## ADDENDUM NO. 2

To: All Planholders  
From: Frank A. Ferris, PE  
Subject: United Irrigation District  
Pump Station E458  
Date: August 20, 2024

UNITED IRRIGATION DISTRICT  
PUMP STATION E458  
STANDPIPE FOUNDATION

RE: United ID E458 Pump Station  
Addendum #2

#### Plan Sheet 20

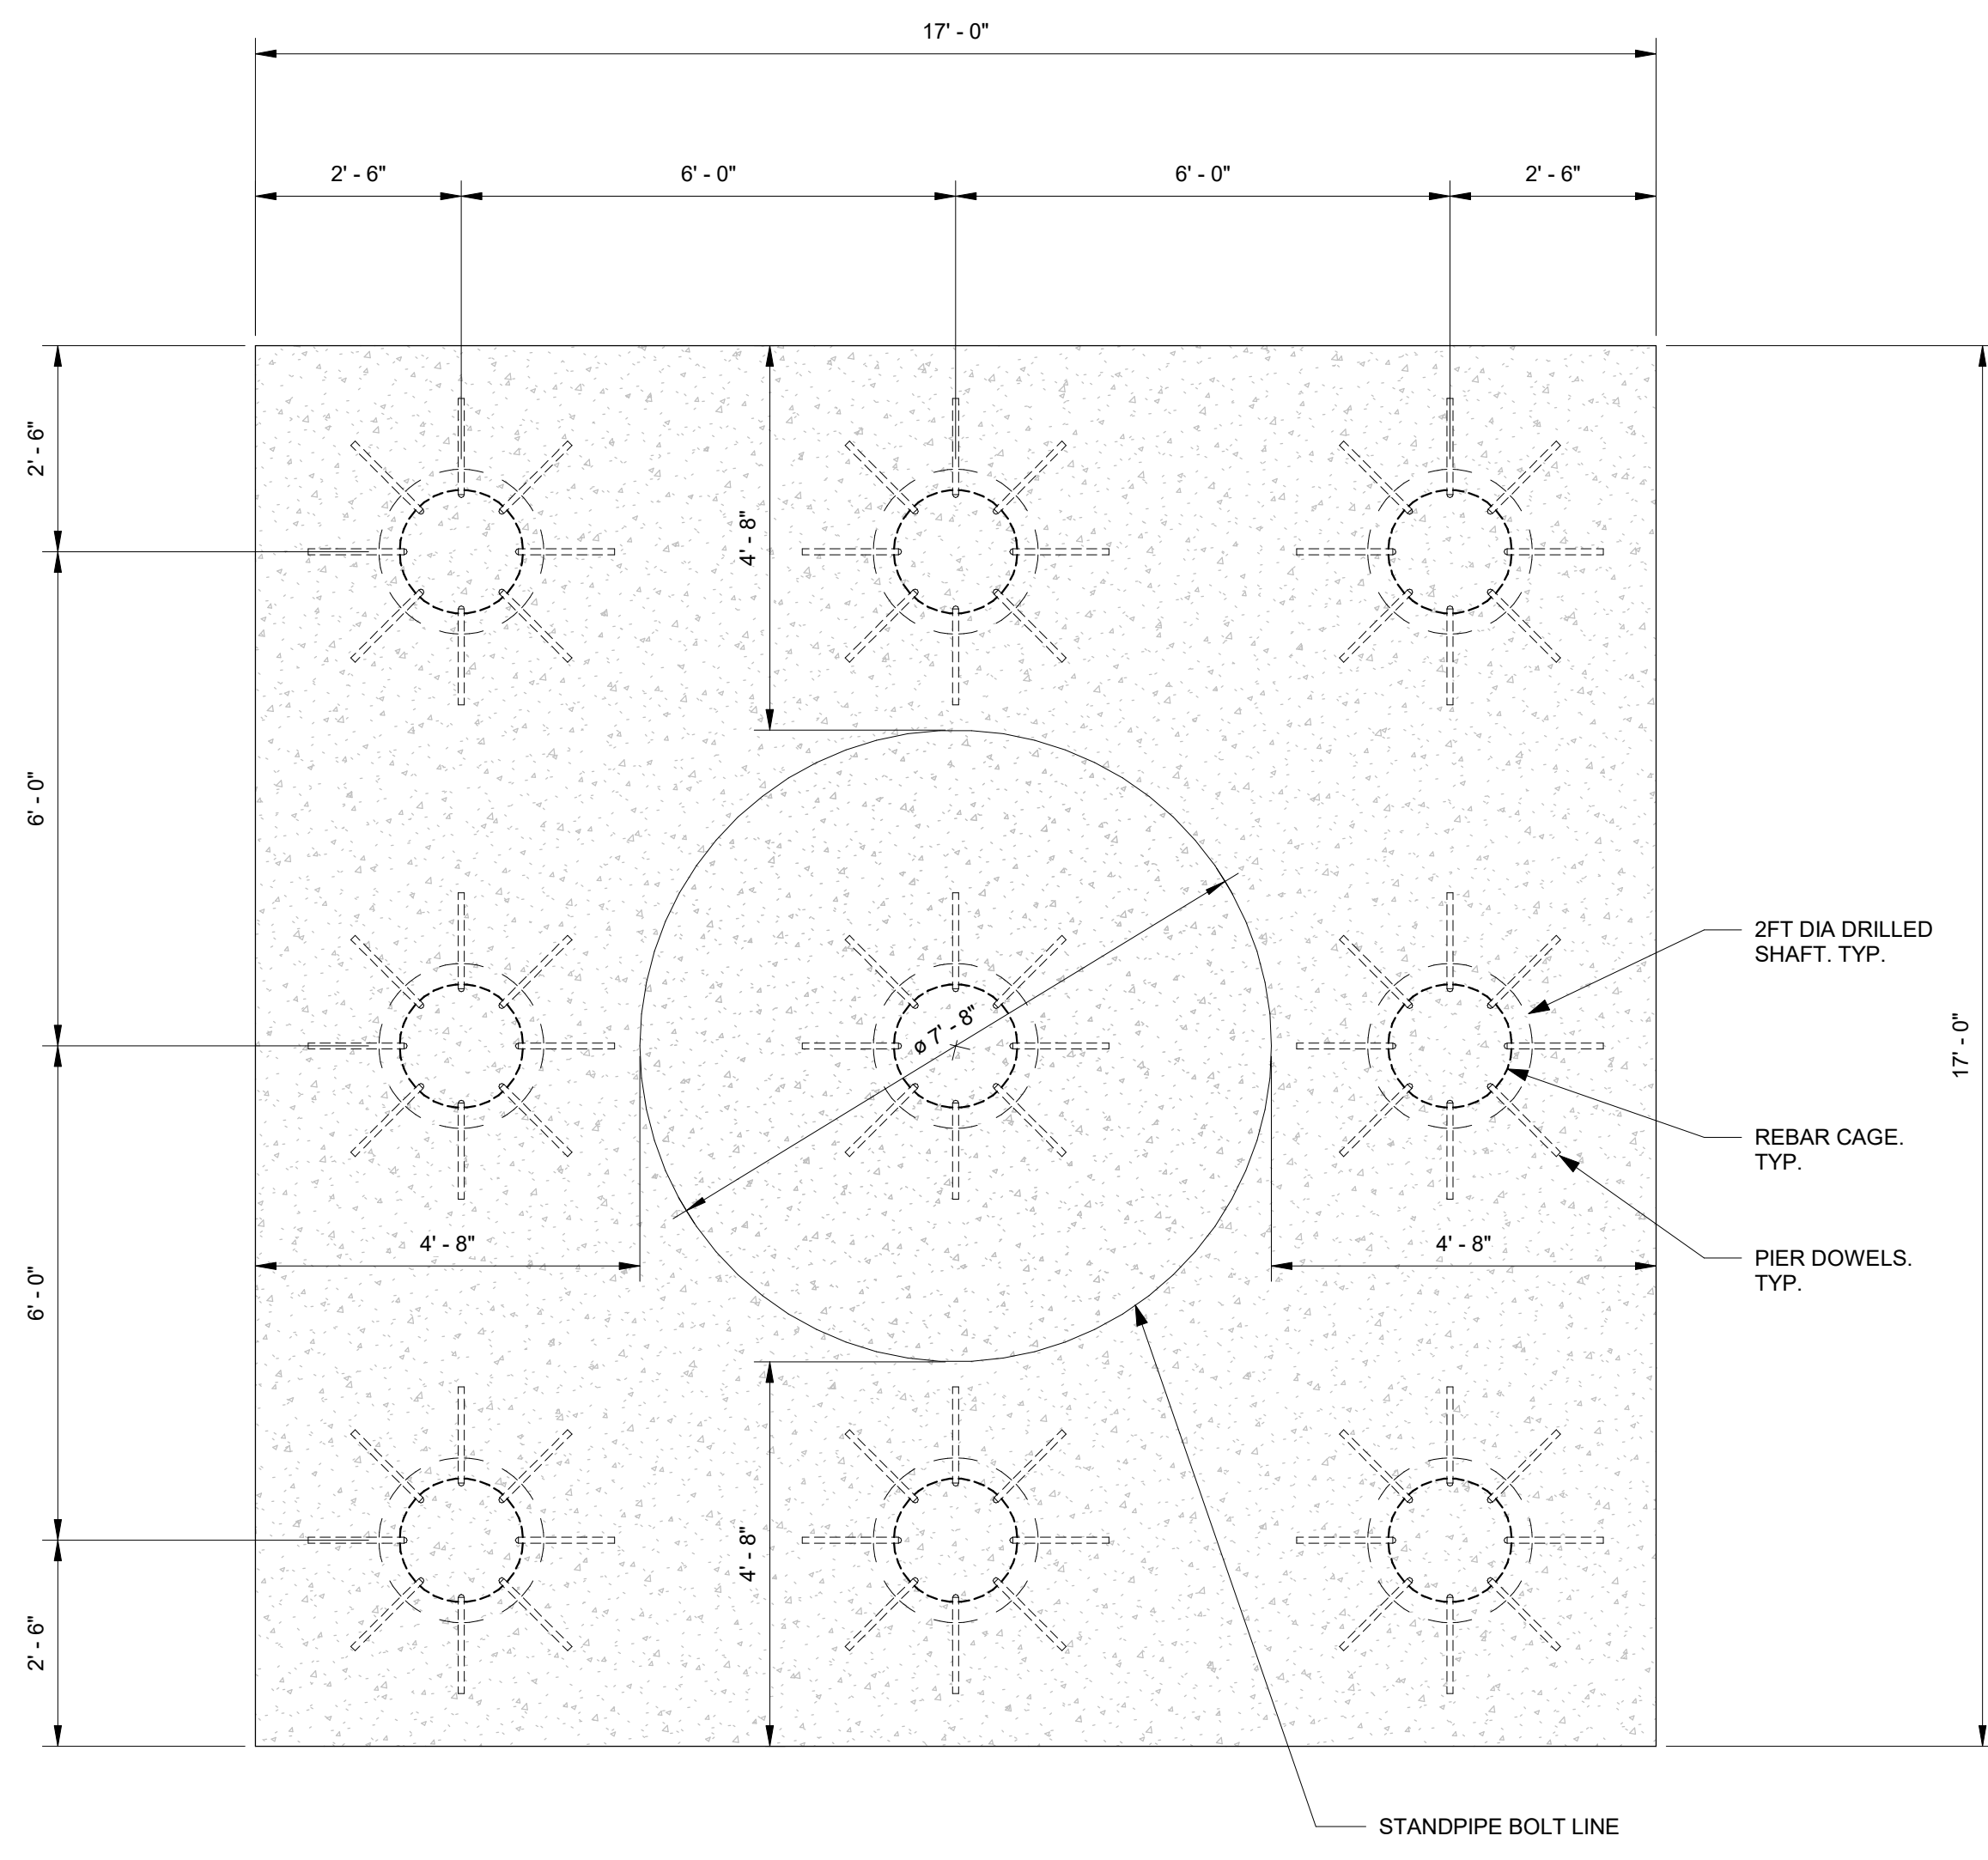
Refer to attached letter from Willard Jordan, PE, regarding Addendum No. 2, and make changes to Plan Sheet 20, accordingly.

Refer to the "SCADA SYSTEM ANTENNA MOUNTING DETAIL" and the RTU-400 Detail on contract drawing sheet 20 and make the following changes to accommodate relocating the SCADA system radio from RTU-400 to the standpipe. The radio shall be furnished complete in a weatherproof enclosure and mounted approx. 5' above grade.

1. Delete the 2" PVC conduit between the standpipe and RTU-400.
2. Furnish and install (F&I) a 3/4" conduit with (3)-#12 (120 vac) between RTU-400 and the SCADA system radio that shall be mounted on the standpipe.
3. F&I a 3/4" conduit with two 2/C, #14 AWG twisted pair shielded cables between RTU-400 and the SCADA system radio.
